CITY OF KELOWNA MEMORANDUM

APPLICATION NO. Z07-0011

PURPOSE:

TO REZONE THE SUBJECT PROPERTY FROM THE RU1 - LARGE LOT HOUSING ZONE TO THE RU6 - TWO DWELLING HOUSING

SIFE PLAN

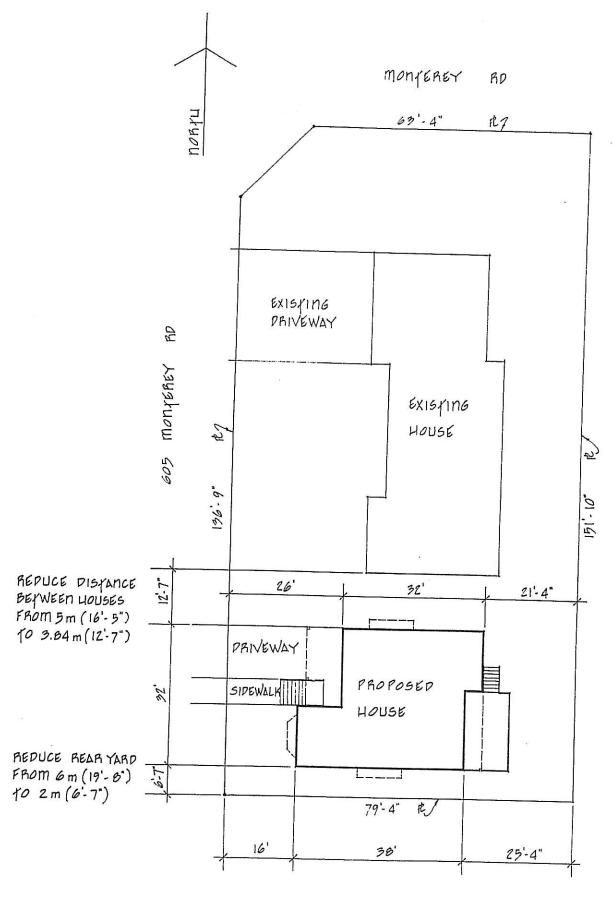
$^{^{\}rm A}$ The site plan shows a 6.5 m dimension to the proposed house, where the actual measurement should be to the raised deck portion of the structure, which is \pm 2.1 m from the east propertly line.

Probable spatial separation problem with proposed distance between existing home and

proposed home, provide calculations to BCBC 2006.
